HISTORIC PRESERVATION COMMISSION

MEMORANDUM

SUBJECT: Historic Area Work Permit #625499

Applicant: Alex and Kristy Sternhell
Address: 27 Primrose Street, Chevy Chase

FOR REAR OF HOUSE SEE 8
ELEVATION OF WEST SIDE
 SIDE ELEVATION
 SCALE: 1/4"=1'-0"

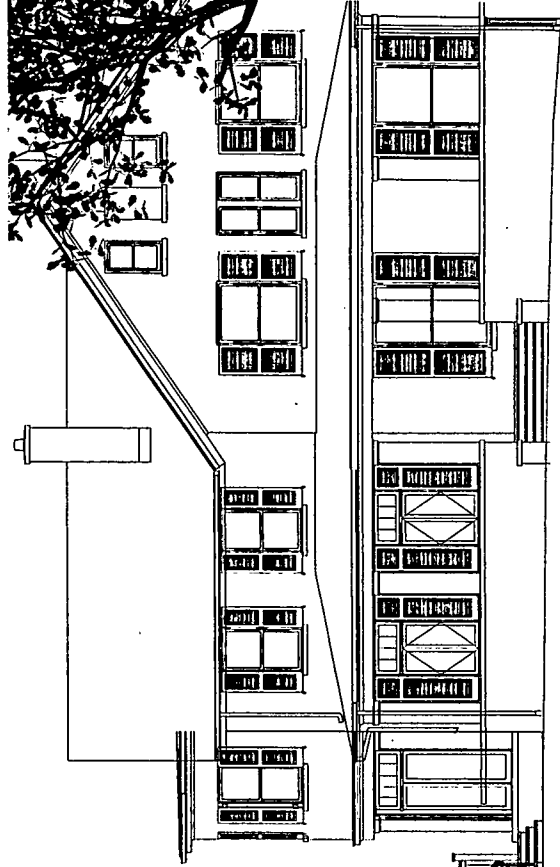
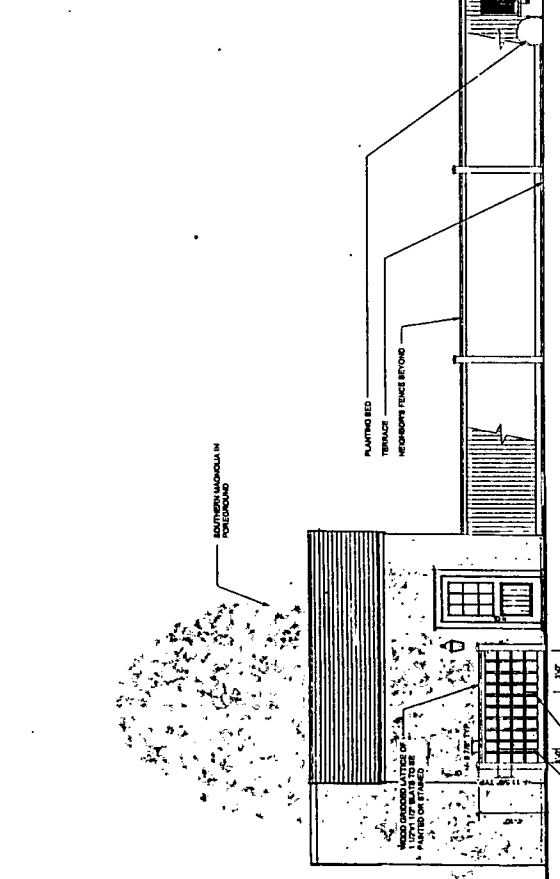
1. The proposed 5' to 6'6" tall fencing in the location shown is not approved; final design and location of west side yard fencing to be reviewed and approved at the staff level.
